# Historic Architectural Review Commission
## Staff Report for Item 14

| Applicant Number: | C2026-0015 |
| Address: | 241 Trumbo Road |

Major Development Plan - New affordable housing development. Total of 150 units.

Exhibit to Demolition Appendix

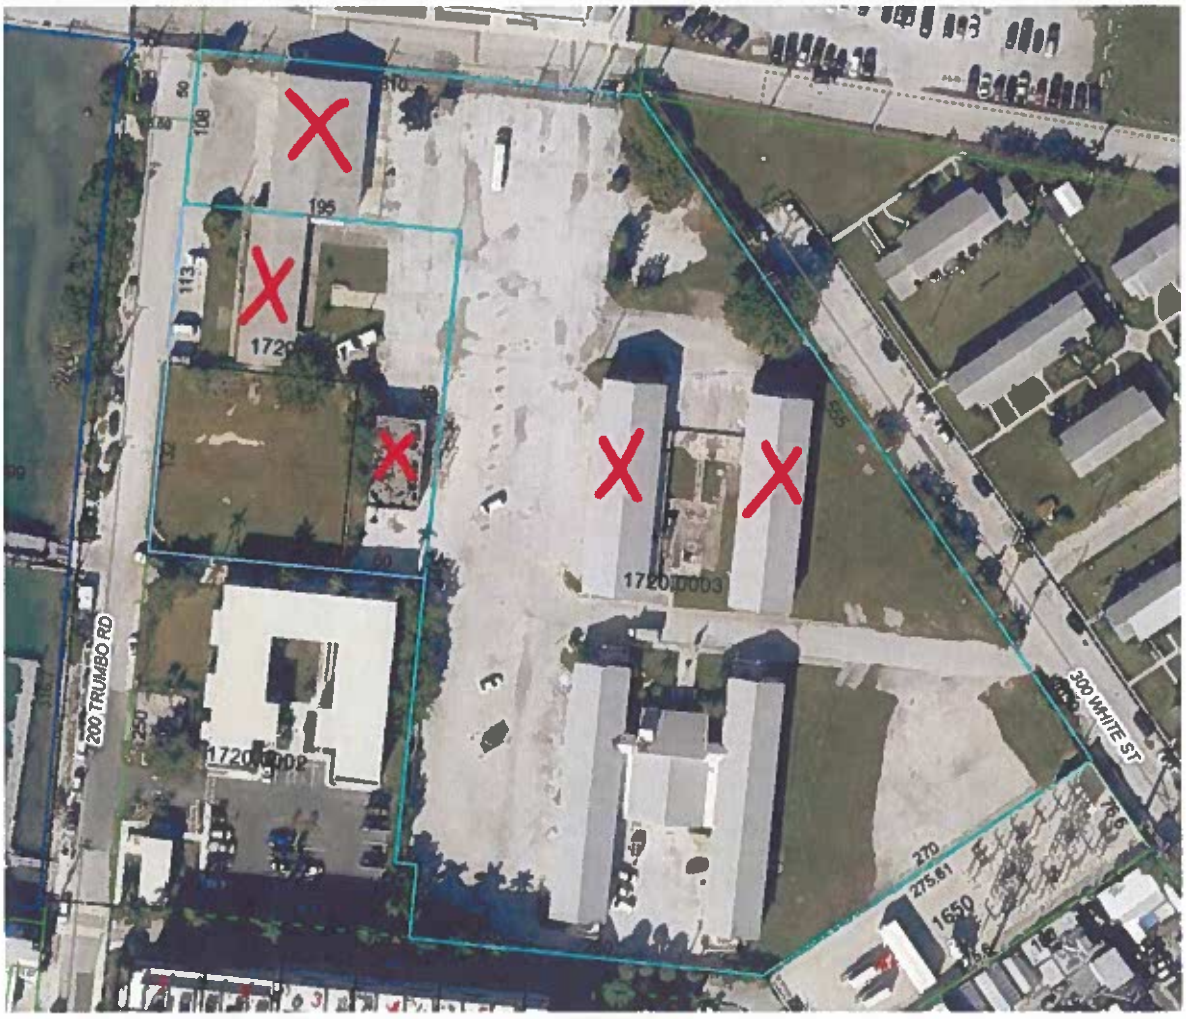
It is the staff's opinion that the request for demolition may be considered, as the structures under review meet the criteria for demolition. Although the buildings are historic, all have limited architectural significance. Multiple buildings has experienced multiple alterations over time, reducing their original historic integrity. If approved, only one reading will be required. Staff will review submitted construction plans for demolition and design to ensure consistency with submitted drawings.

Proposing demolition of 5 existing buildings that were previously used by the school district as offices, warehouses, and bus maintenance. See photos provided that show the complete deterioration of the existing buildings. The 5 buildings proposed for demolition are identified in the attached exhibit.
